**URGENT: MEDICAL DEVICE CORRECTION****OLYMPUS DUODENOSCOPES**

<b>Product Name</b>	<b>Model Number</b>	<b>Serial Numbers</b>	<b>UDI DI</b>
Evis Exera III Duodenovideoscope	TJF-Q190V	All	04953170405563 04953170452024

Date: 14-OCT-2025

Figure 1: Visual Inspection Guide for distal end: Front side/Back side

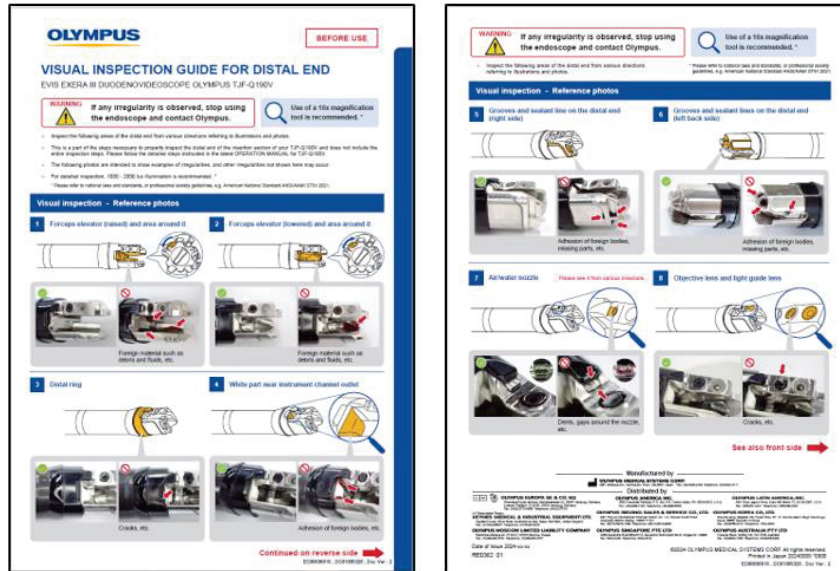
- Olympus created a Visual Inspection Guide to provide clear directions for inspecting the device for potential irregularities and damage. The guide recommends the use of 10X magnification tools for enhanced visual inspection of the endoscope (see Figure 1).
